Site 3 - Australia Towers II
Sydney Olympic Park

Approved Section 75W Modification Application

No. **MOD 4** granted on the **7/10/14**

in respect to MP **10-0027**

East Elevation

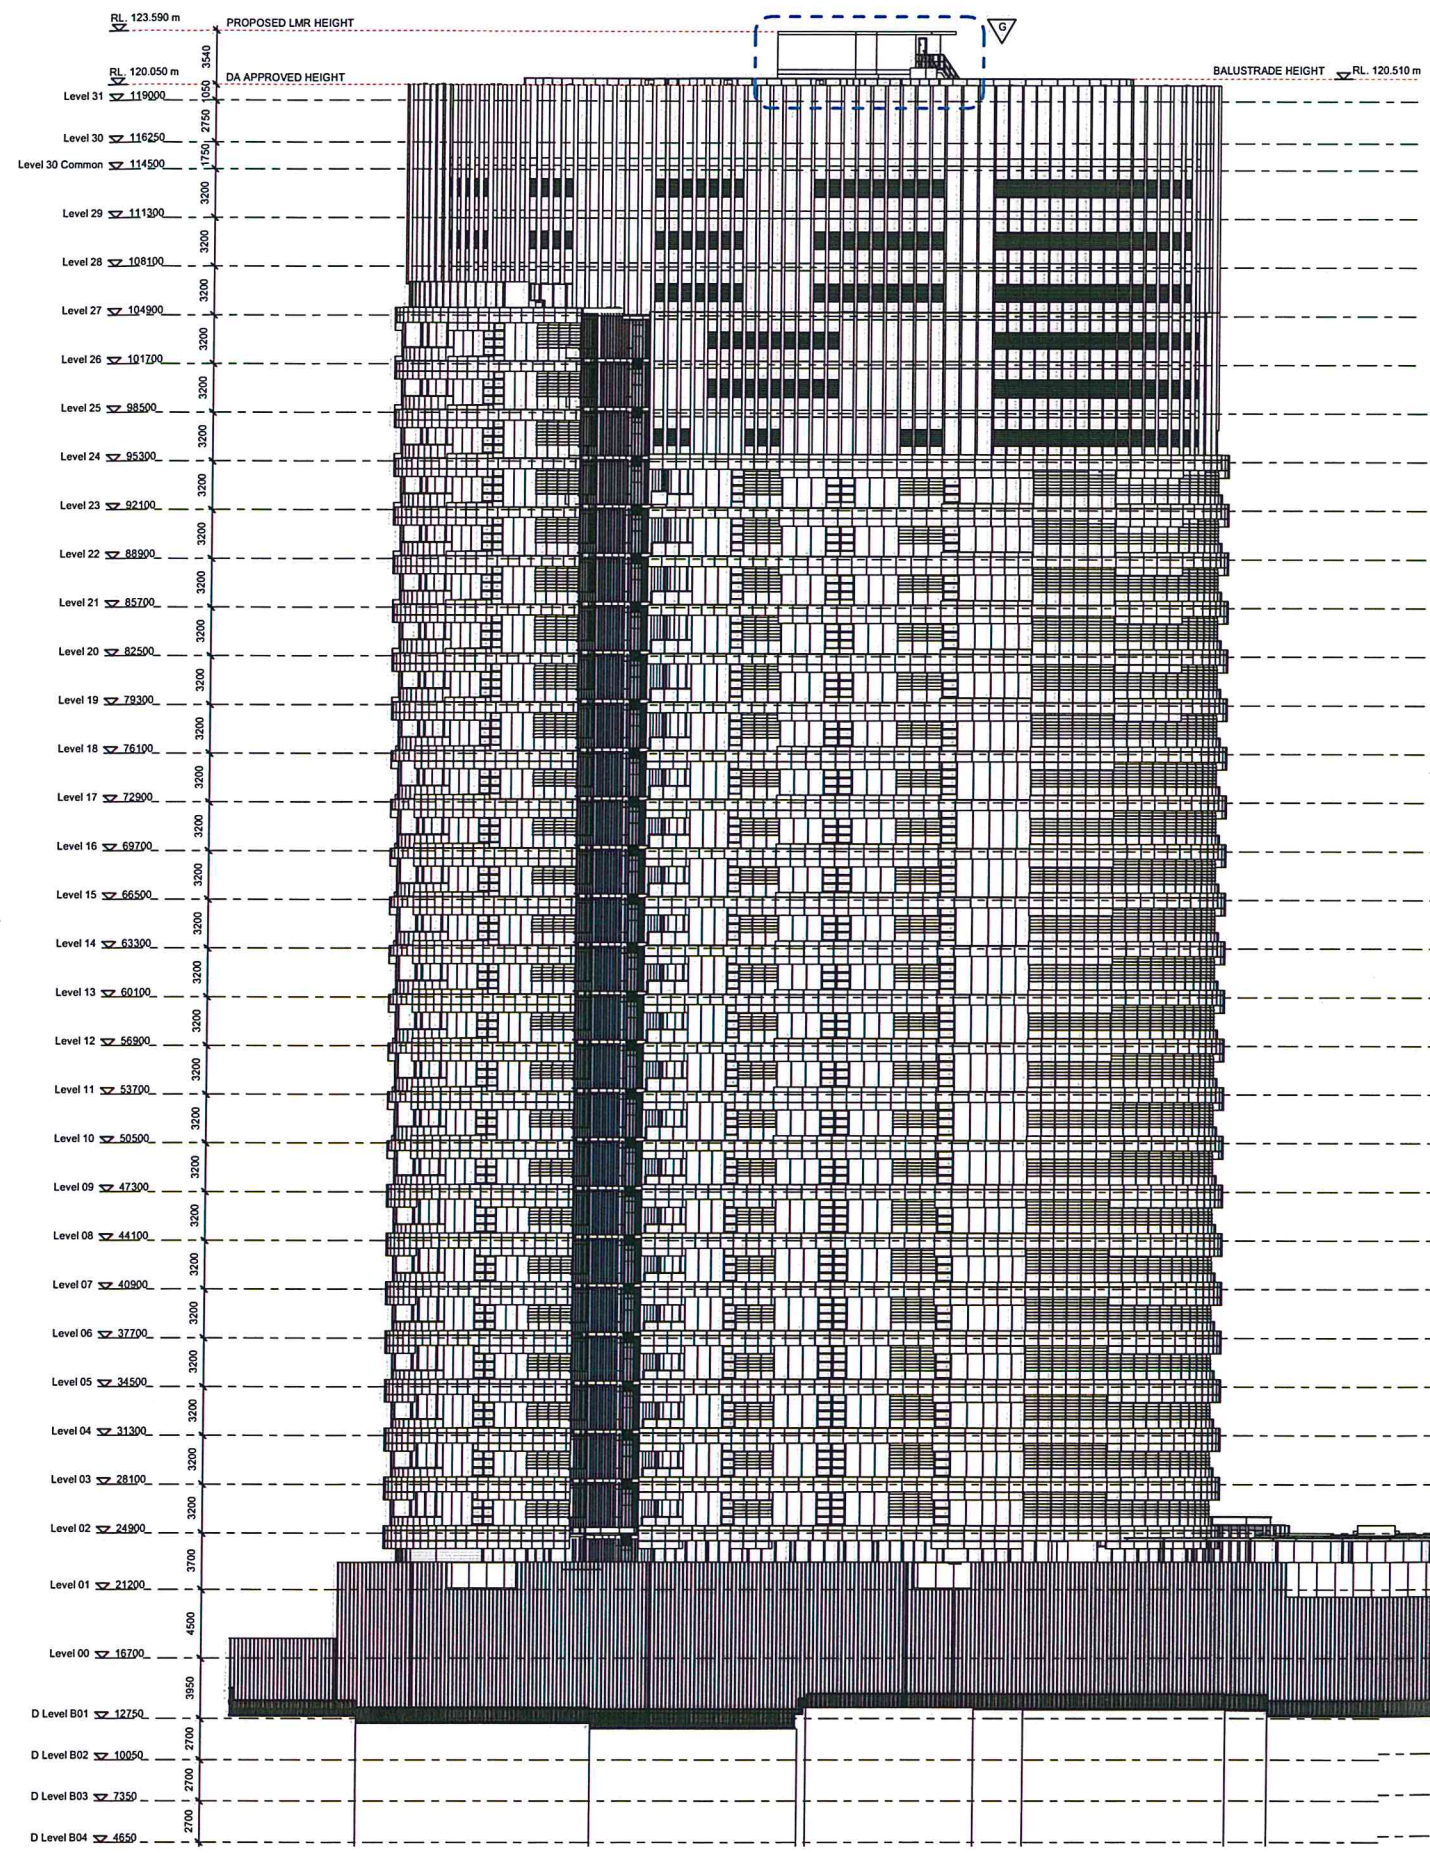
- Tower C
 - 1 additional unit at L24.
- Tower D
 - 2 additional units at L30.
 - LR Motor Room revised.
- Common Area
 - L00/L01 Retail and Commercial layout revised.

1 Section BB
1:200

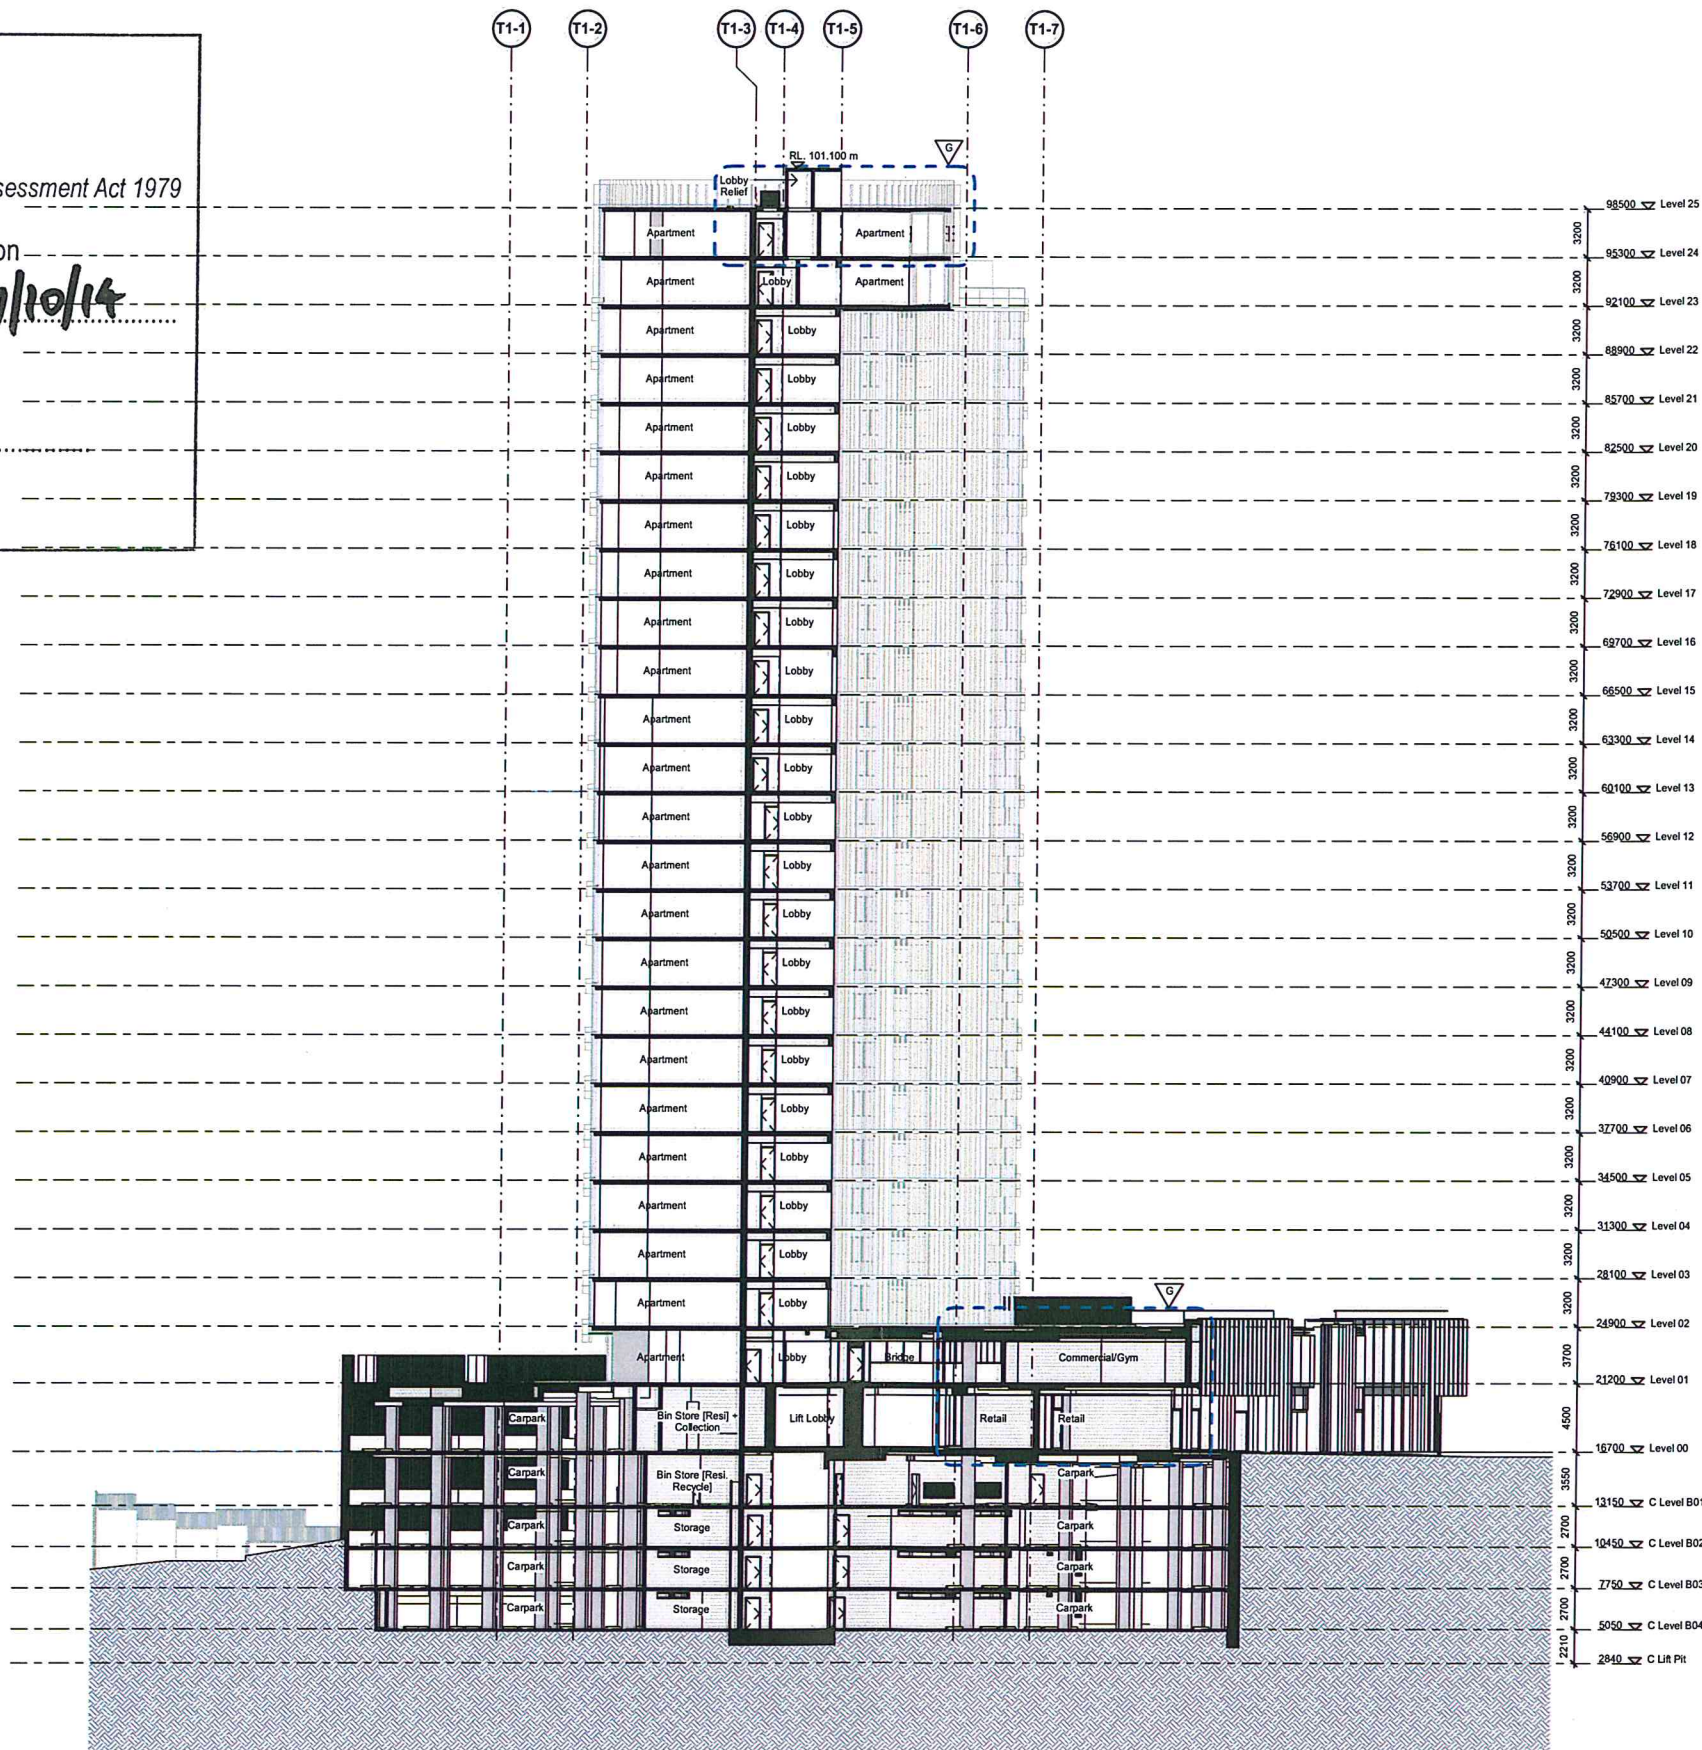
- Revised Notes:**
- Tower C
- 1 additional unit at L24.
 - Tower D
- 2 additional units at L30.
- Lift Motor Room revised.
 - Common Area
- L00/L01 Retail and Commercial layout revised.

**Site 3 - Australia Towers II
Sydney Olympic Park
Section DD**

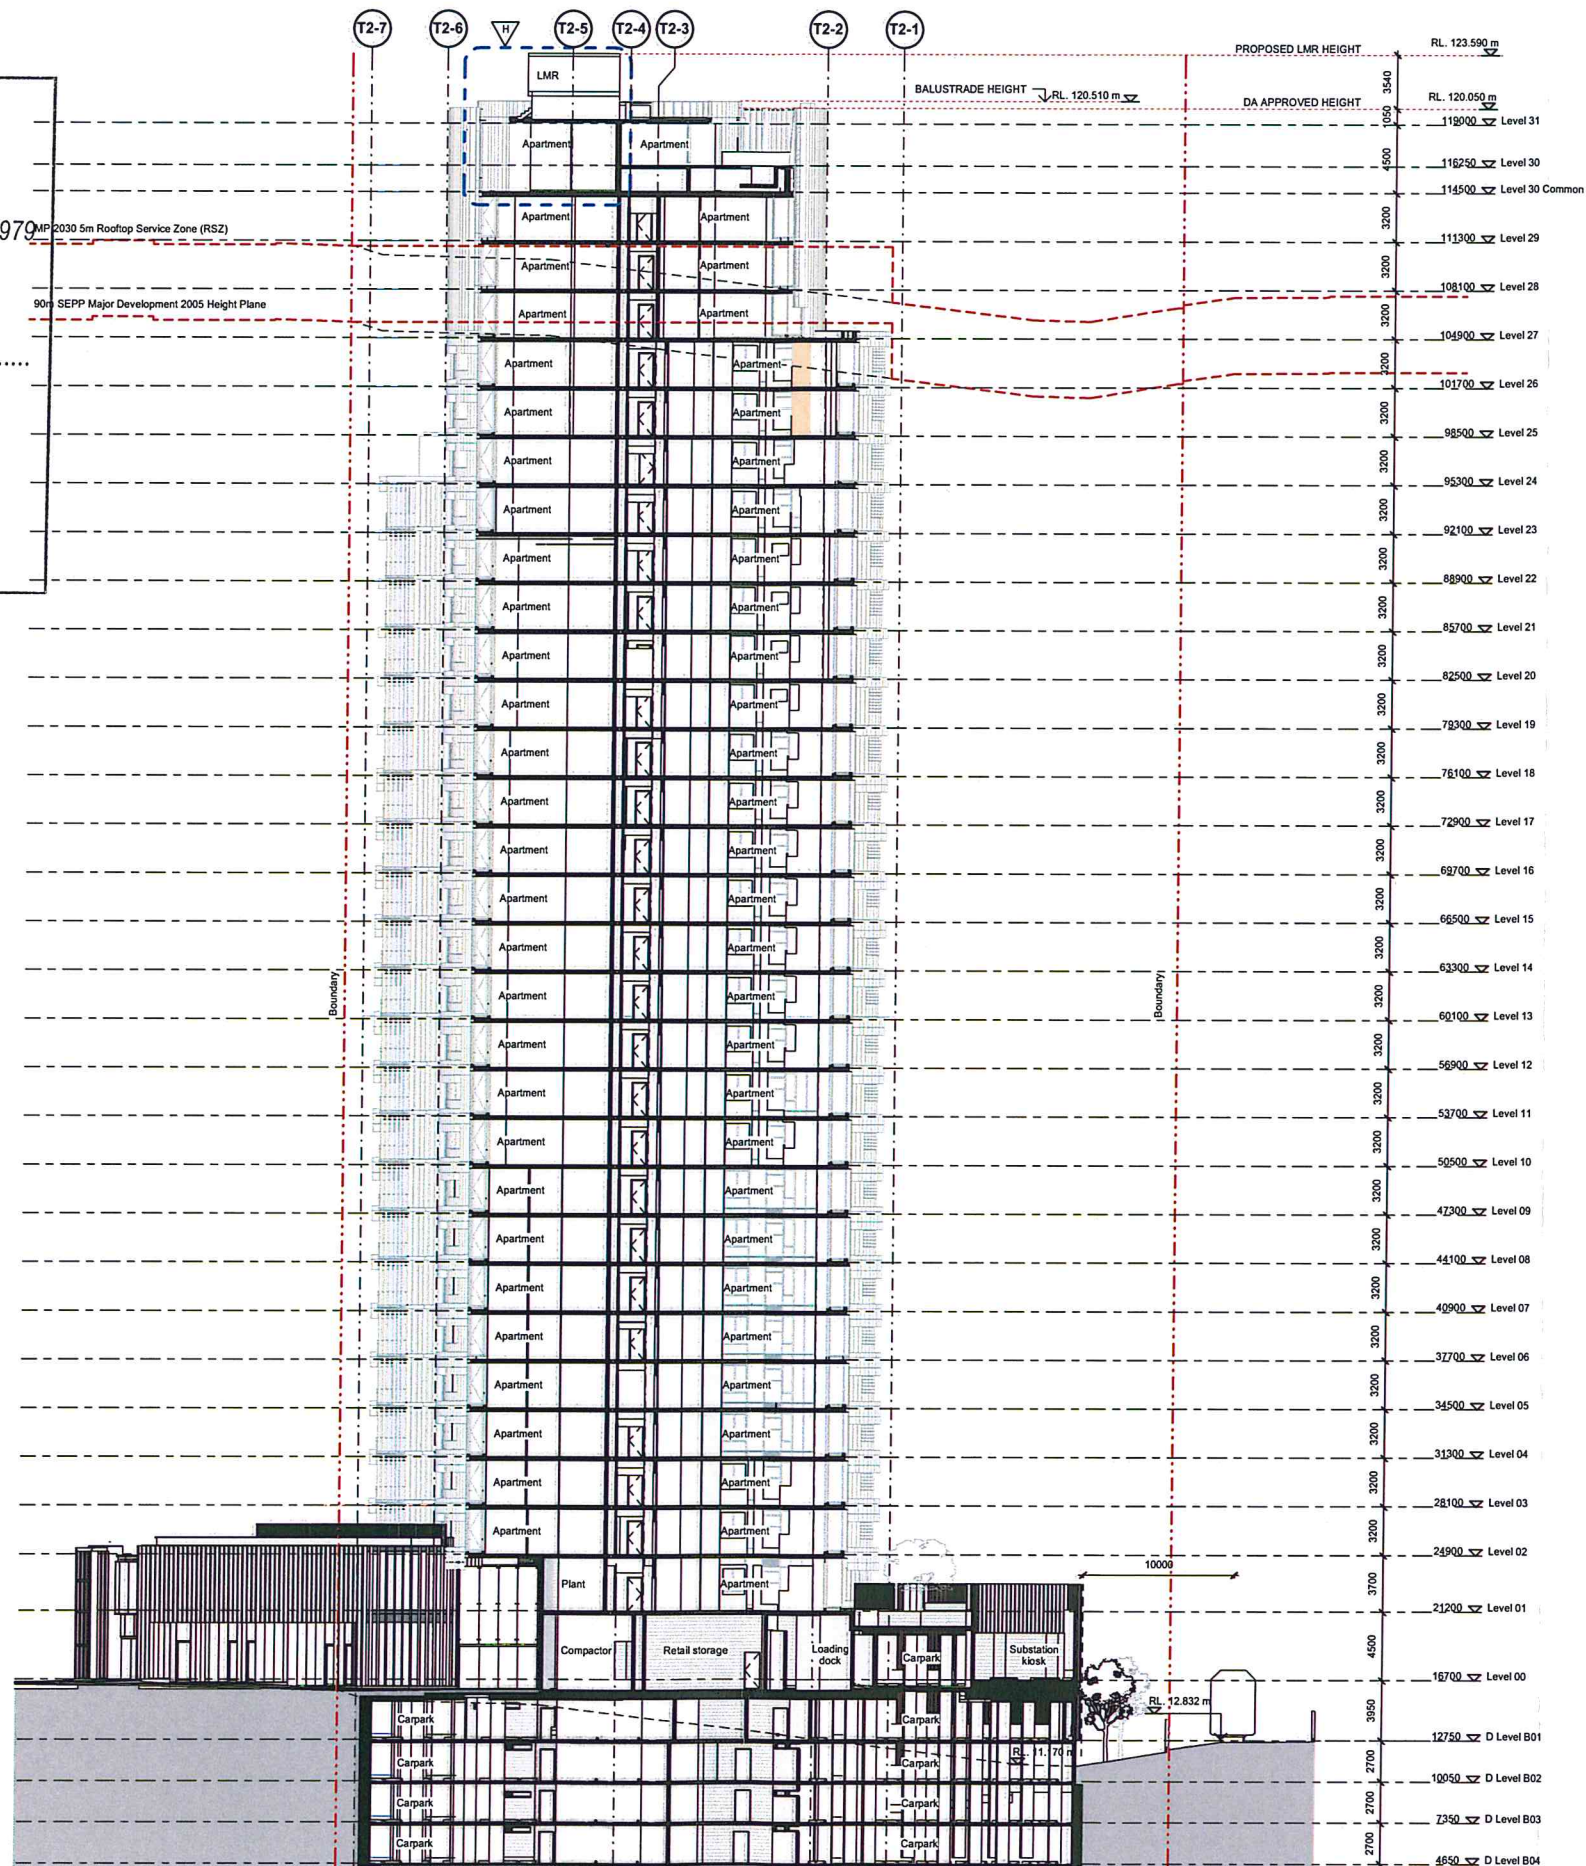
Revision	Date	Description	Initial	Checked
H	09/09/14	S75W Issue	JT	EC
G	22/04/13	S75W Issue Conversion of D30 (D14 B&C) and D30 (D14 B&C) single storey apartments into two storey apartments - L&R extended	DL	MD
